Project	<b>IEEE 802.16 Broadband Wireless Access Working Group</b> < <a href="http://ieee802.org/16">http://ieee802.org/16</a> >	
Title	<b>Revision of Hand-over Mechanism for Mobility Enhancement</b>	
Date Submitted	<b>2003-11-7</b>	
Source(s)	Phillip Barber Broadband Mobile Technologies, Inc. 8302 Sebastian Inlet Frisco, Tx 75035	Voice: +1 (972) 365-6314 Fax: +1 (925) 396-0269 <a href="mailto:pbarber@BroadbandMobileTech.com">[mailto:pbarber@BroadbandMobileTech.com]</a>
Re:	Response to IEEE 802.16e-03/23 (Call for Contributions on IEEE 802.16e/07r4)  Response to Session 27 Minutes remand C802.16e-03/54r0 to Ad Hoc Group for refinement and continued revision	
Abstract	Clarification, revision, and definition of Hand-over mechanism for Mobility Enhancements	
Purpose	Stimulate discussion on a more completely defined, flexible model and mechanism for facilitating mobility functionality	
Notice	This document has been prepared to assist IEEE 802.16. It is offered as a basis for discussion and is not binding on the contributing individual(s) or organization(s). The material in this document is subject to change in form and content after further study. The contributor(s) reserve(s) the righ

**Figure D.10—Sleep mode**

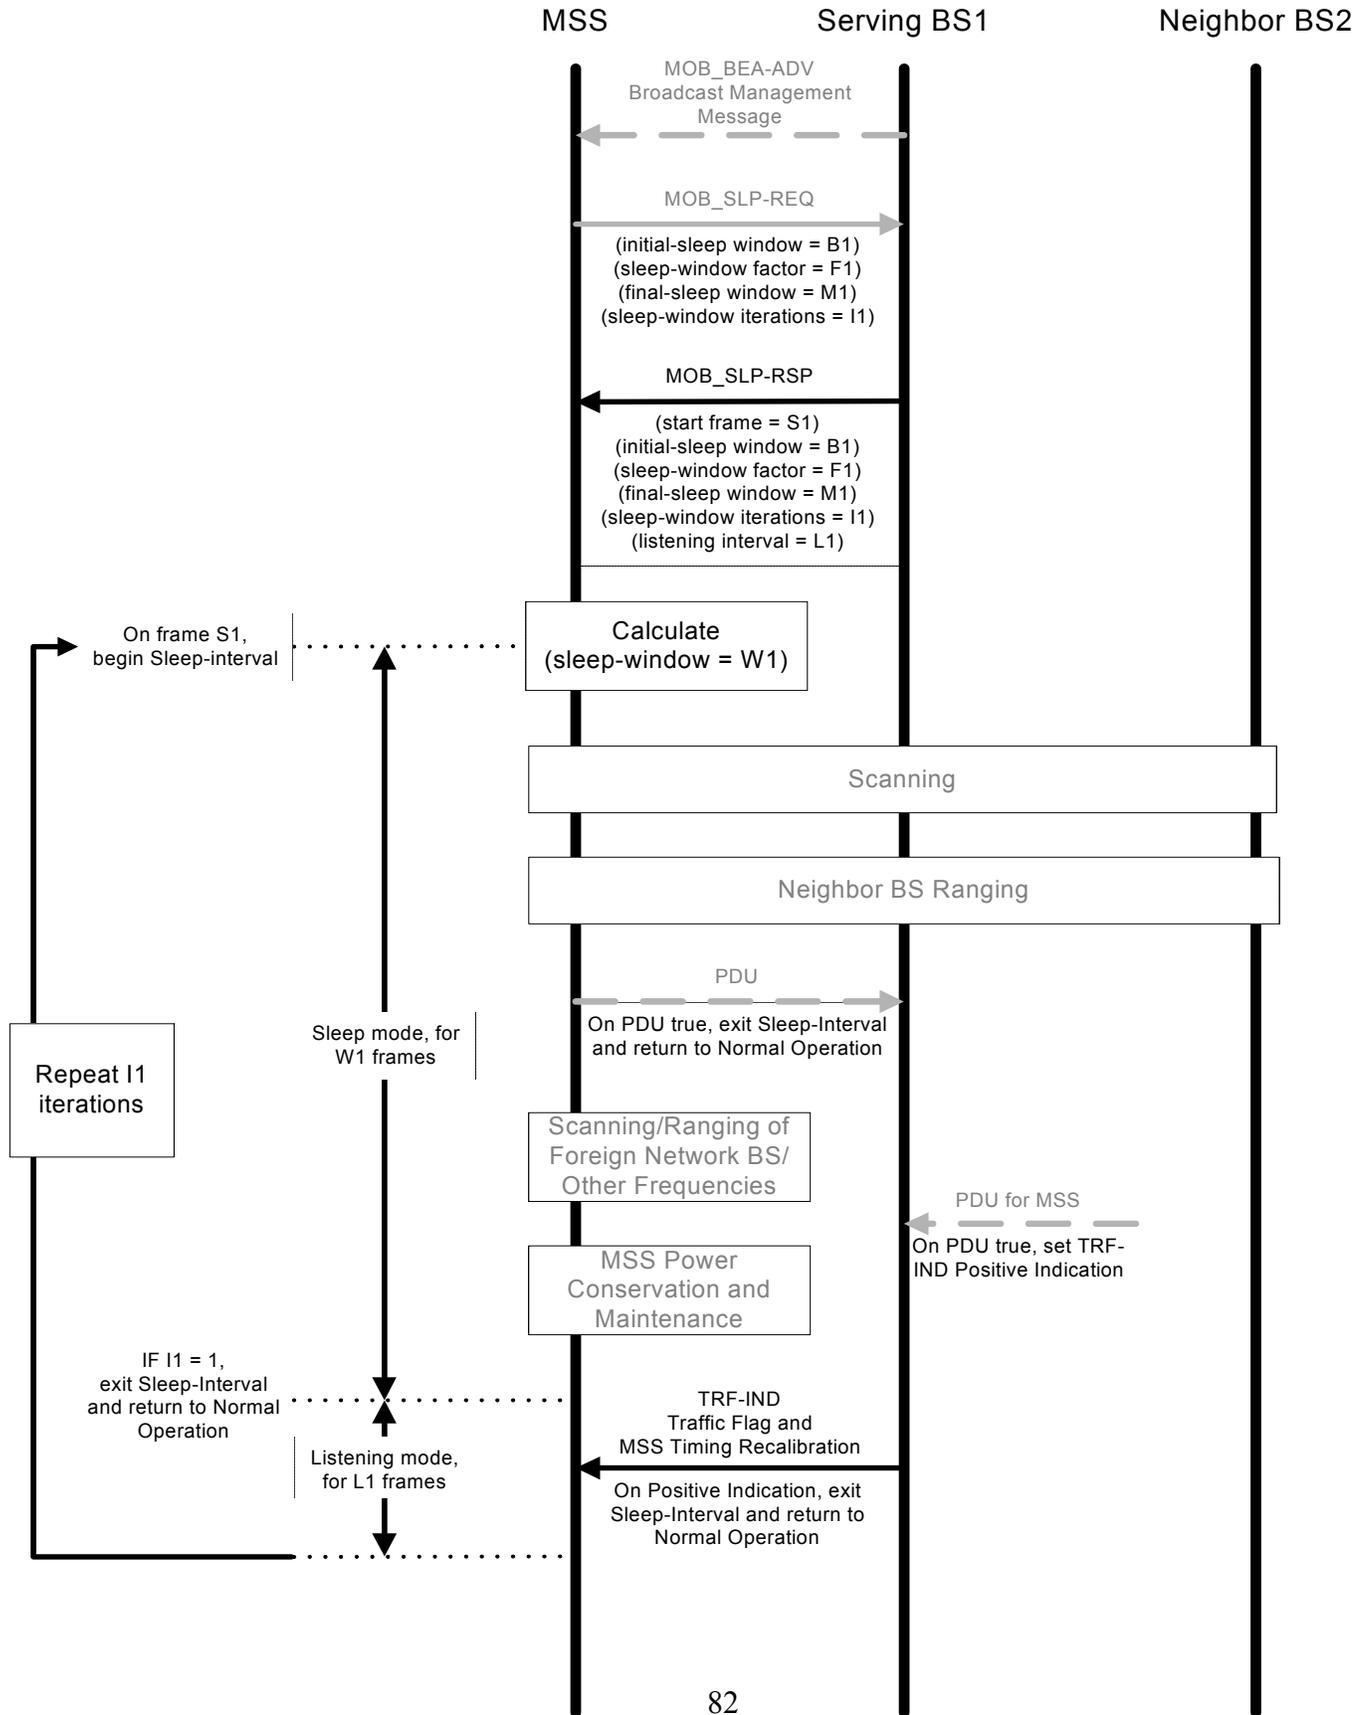
*[In Annex D.2, page 61, replace **Figure D.10**, **D.11**, and **D.12** entirely with:]*
